**CALIFORNIA COASTAL COMMISSION**

**STAFF REPORT: REGULAR CALENDAR**

**APPLICATION NUMBER:** 5-01-377  
**APPLICANT:** Patrick Loo  
**AGENT:** Neman Niaki  
**PROJECT LOCATION:** 3509, 3511 Grand Canal, Venice (Los Angeles County)  
**PROJECT DESCRIPTION:** Construction of a stair enclosure structure on the existing roof deck of an existing two-unit multiple family residence.

EXHIBIT # 2  
PAGE 1 OF 1  
**5-01-377**

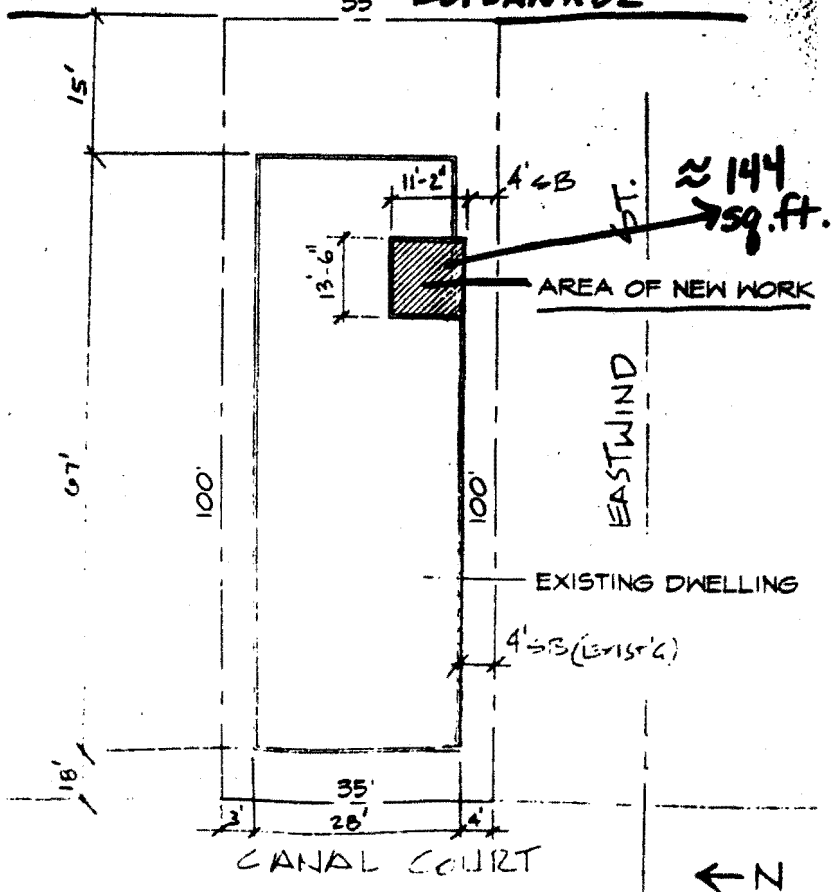
The proposed roof access structure is 4-feet high above the roof level, which is consistent with the 10-foot limit in LUP policy I.A.1.a. (i.) However, the second LUP standard for roof access structures, Policy I.A.1.a. (ii.) above, requires that the roof access structure be designed and oriented so as to reduce its visibility from adjacent public walkways and recreation areas. The proposed structure is located on the Esplanade side of the building where it would be clearly visible from the Esplanade (City right-of-way) and the Canal. Therefore, the proposed development is not consistent with the certified LUP (Exhibit #2).

EXHIBIT # 3  
PAGE 1 OF 1  
5-01-377

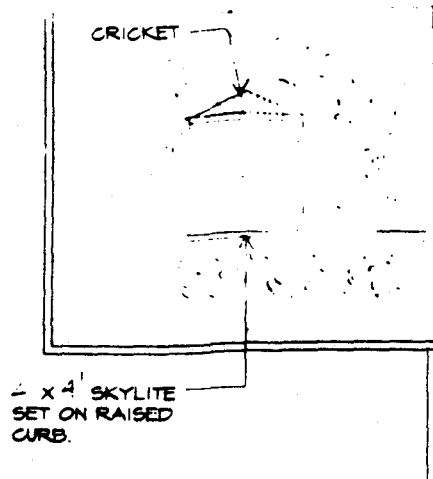
The proposed 34-foot high addition is located approximately 20 feet inland from the Esplanade, which would locate it within the 60 horizontal feet limit. Therefore, the development is not consistent with the Venice Land Use Plan Policy I.A.7(b).

The City's fourth LUP roof access structure standard, Policy I.A.1.a.(iv.), requires roof access structures to be set back at least 60 horizontal feet from the mean high tide line of Ballona Lagoon, Venice Canals, Grand Canal and the inland side of the Esplanade (City right-of-way). The proposed structure is located within 20 feet of the Esplanade and is therefore inconsistent with the Venice certified LUP.
